# UNITED STATES PATENT AND TRADEMARK OFFICE

APPLICATION NO.	FILING DATE	FIRST NAMED INVENTOR	ATTORNEY DOCKET NO.	CONFIRMATION NO.
10/809,304	03/24/2004	Wenman Li	yeh-pt008	6519

## Office Action Summary

## DETAILED ACTION

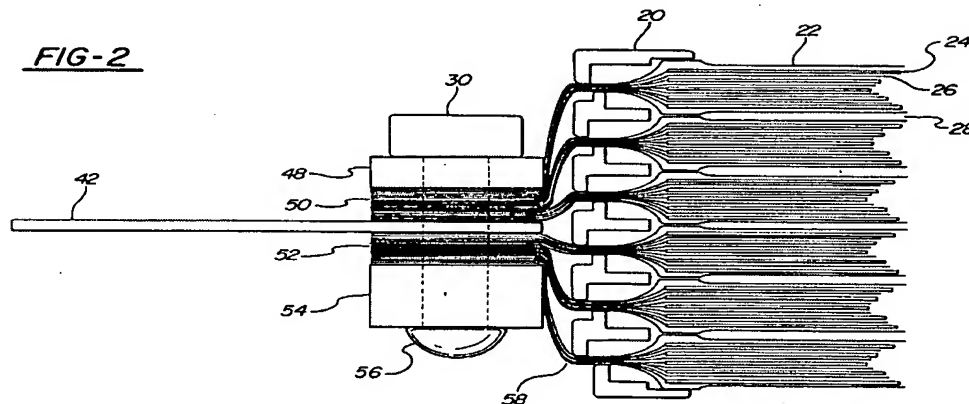
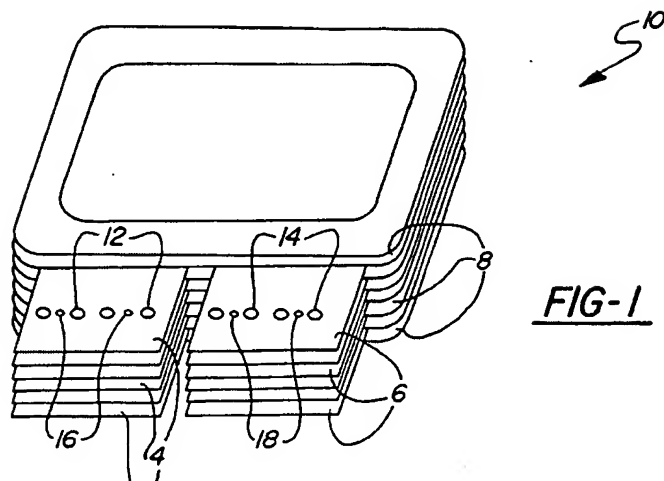
Tura et al disclose a method of tab bussing for a multicell battery (COL 1, lines 65-67 & lines 5-10/ CLAIM 1) wherein each cell includes an anode, a cathode and an electrolyte separating the anode and the cathode (*the stacked anode/membrane/cathode*), and at least one tab with at least one hole therein (*the punched current collector*); the battery includes at least one holding device such as rivets 30 passing through a hole in a tab of each cell and is secured to the tabs (Col 2, lines 15-20/ COL 3, lines 15-25/FIGURES 1-2) which is then connected to terminal 42 (*the lead*).

The method comprises a step of forming at least one hole through a tab of each individual cell, and inserting into a hole in a tab of each cell a holding device and securing the holding device to the tabs (COL 2, lines 1-5/ FIGURES 1-2). Tura et al discloses the method of tab bussing includes forming holding holes in the anode/cathode tabs and in terminal 42 by drilling or stamping (COL 4, lines 9-20) and the step of aligning these features (COL 4, lines 15-32); and the step of inserting into the hole formed therethrough first/second holding devices (Claim 1).

**Figures 1-2** above illustrate the use of multiple holding devices associated with a single tab (CLAIM 1). Thus, the requirement of varying the number of rivets and points of riveting is met because: 1) such a limitation is not recited in a positive manner (i.e. "may vary") so that a clear number of rivets and points of riveting is set forth therein. The language "may vary" has been interpreted as an optional step; or 2) the prior art uses at least more than one (1) bolt (rivet) for connecting current collectors. Thus, the prior art at once envisages using a number of rivets and points of rivet other than just one.

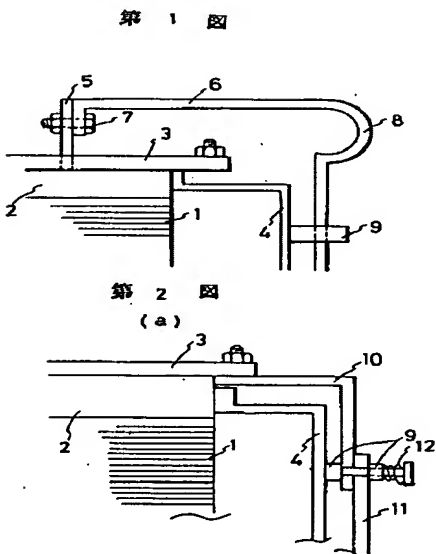
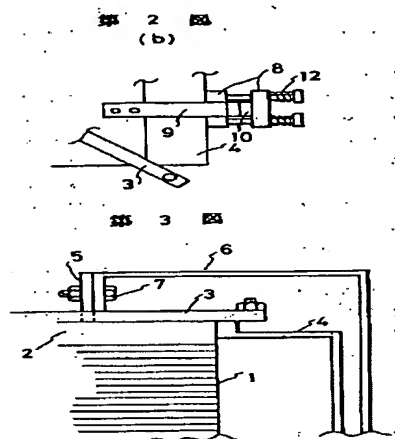
**Figures 1-2** below of JP'376 clearly illustrate a laminated cell comprising a matrix for holding electrolyte and gas diffusion electrodes (ABSTRACT/CONSTITUTION) and current collector plates 2 (*first and second current collector plates connecting electrode of multiple cells*) mounted on the top and bottom faces of the cell and clamped with a metal clamping fitting 3, and a bus bar 6 (*the leads*) is fixedly mounted on a current lead terminal 5 projecting from the current collector plate 2 by making use of a clamping bolt 7 (*the rivets*) (Abstract/Constitution).

**Examiner's note:** the JP'376 explicitly discloses all the features mentioned above. As such, the JP'376 must implicitly disclose a method of assembling all of the above features comprising the steps of alternately stacking electrodes and an electrolyte matrix to form a cell; and aligning punched lead terminals 5 which are then fastened to a bus bar 6 (the lead) by using a bolt 7 (the rivet).

**Figures 1-2** above illustrate the use of multiple bolts associated with a single current collector. Thus, the requirement of varying the number of rivets and points of riveting is met because: 1) such a limitation is not recited in a positive manner (i.e. "may vary") so that a clear number of rivets and points of riveting is set forth therein. The language "may vary" has been interpreted as an optional step; or 2) the prior art uses at least more than one (1) bolt (rivet) for connecting current collectors. Thus, the prior art at once envisages using a number of rivets and points of rivet other than just one.
